NO. 153A AMPLIFIER
FOR USE WITH HEAD TELEPHONE SETS

1.01 This addendum supplements the section and replaces Fig. 5. Fig. 5A is added to maintain correct polarity where current reversal is made by central office or PBX.

Fig. 5A-Modified Circuit For Nonpolarized Use With 4A Key Equipment.

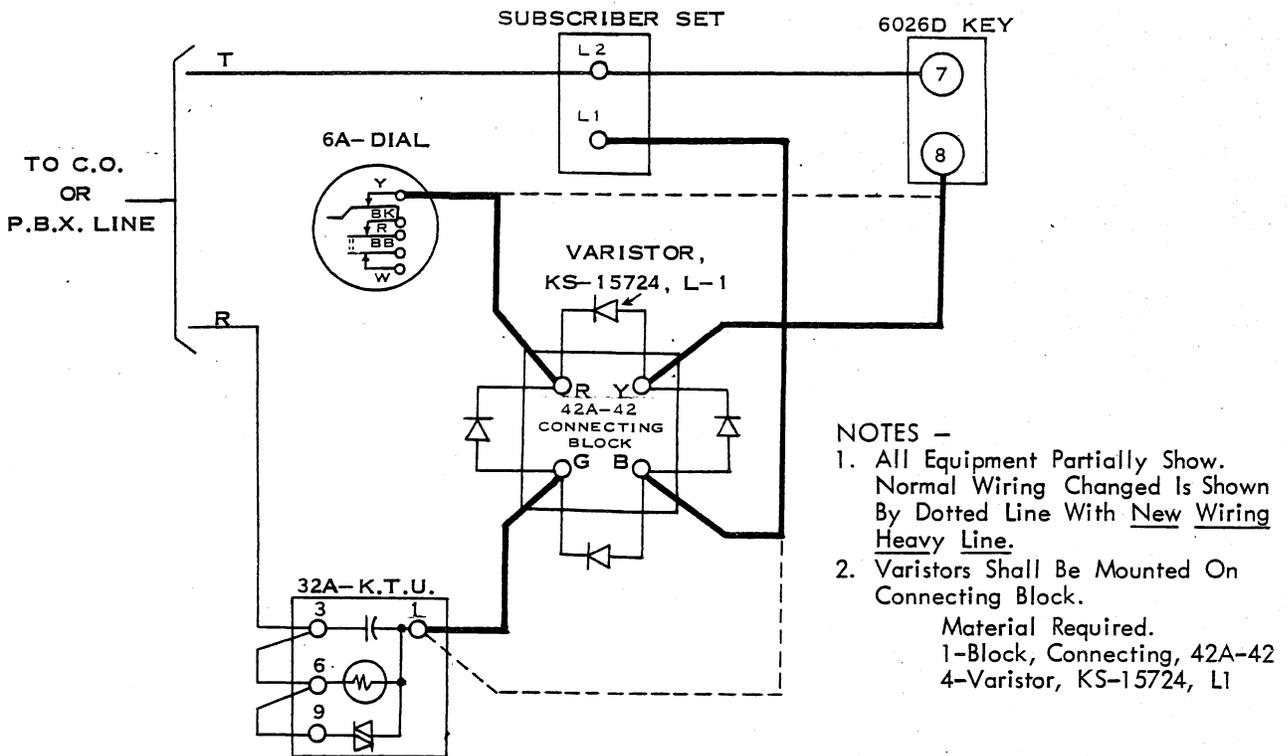
- (a) Paragraph 3.04 of the section is replaced by paragraph 3.04 of this addendum.
- (b) Fig. 5A of addendum is added, due to inadequate space in the 153A

amplifier for placing semi-conductor diodes or varistors.

3.04 In cases where it is necessary to use this amplifier under conditions as in 3.03, where talking battery is reversed, during a call, or from call-to-call, provision has been made to modify the amplifier to function under these conditions. A full-wave rectifier bridge consisting of four KS-15724 L1 varistors is inserted in the power leads and wired as shown in Fig. 5A.
